Please scan as correspondence with agent

CM/64/19/PL and CM/16/20/PL

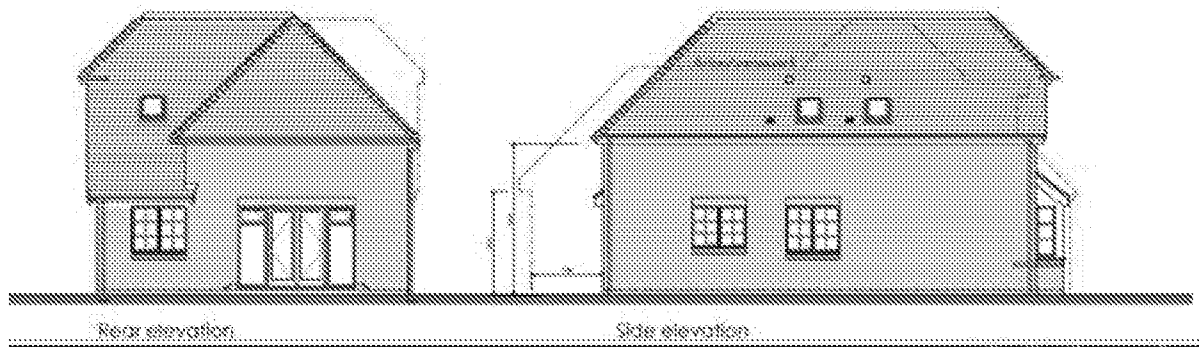
Please see an extract of a representation I have received . Can you provide comment on the differences between the plans and why it seems there is a difference in the approved drawings when they are imposed over the proposed by him?

Below is a photo of the plans of plot 8, CM/64/19/PL and plot 8, CM/16/20/PL. I have traced the outline of CM/64/19/PL on to CM/16/20/PL. Both plans were drawn to the same scale as the widths of the two designs are identical and both were printed out on the same printer. You will notice that my red dotted outline appears significantly different to the one supplied by the applicant – see below. Not only does the roof appear higher but also longer. This leads me to believe that either the original plans have been altered or the architect has made a mistake drawing in the red dotted outline on the new plans.

The length of the house is as shown, however the positioning of the plot is relative to the parking bay in front, consequently we have tried to move new the plot as far north as we can so as to limit the impact at the rear. To locate the plots, the corner of the window bay is the same in both versions (as per the plans I sent you recently) but the posts and overhangs are not the same in both schemes, hence the slight difference in appearance/length.

In respect of the dotted roof/ridge lines it appears the representation shows a much lower roof line which is in fact the rear of the previous scheme, whereas we have shown the front of the outline of the previous scheme. For clarity, I am attaching an image showing the both the front roof and the rear roof superimposed over the rear elevation.
